# DEVELOPMENT REVIEW BOARD REPORT

**37-DR-2005**  
**Abrahamsen Residence**

Request approval for a site plan and elevations for a new residence above an existing professional office.

## **Stipulations for Case: Abrahamsen Residence Case 37-DR-2005**

## SITE PLAN / LANDSCAPE PLAN

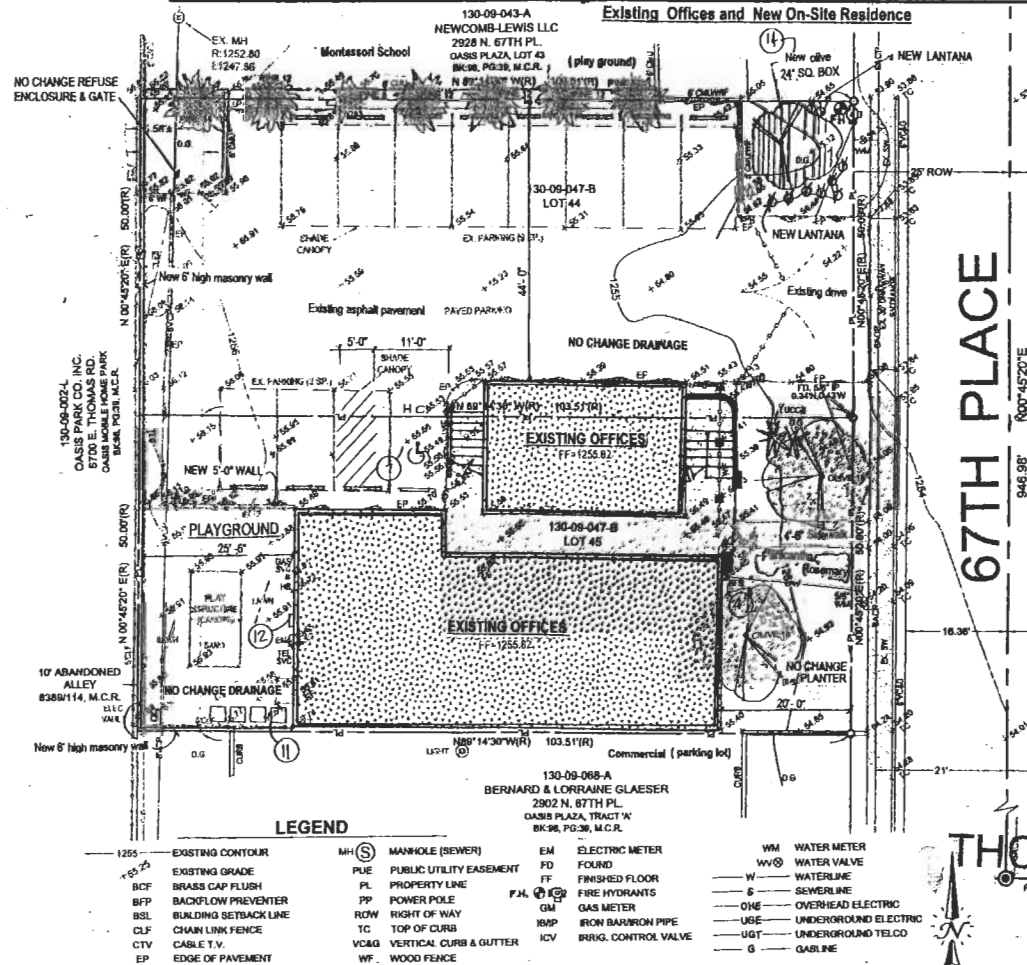
2. Existing chain link fence shall be removed and replaced with masonry stucco wall painted to match the building on all sides.
3. All walls shall match the architectural color, materials and finish of the building(s).

11. The front yard setback shall be 20 feet as approved by the Development Review Board.

- 14. The site plan shall be revised at time of final plans to show the location of the bike parking.
- 15. Bike rack design shall be in conformance with City of Scottsdale M.A.G. Details unless otherwise approved in writing by the City of Scottsdale's Transportation Department.
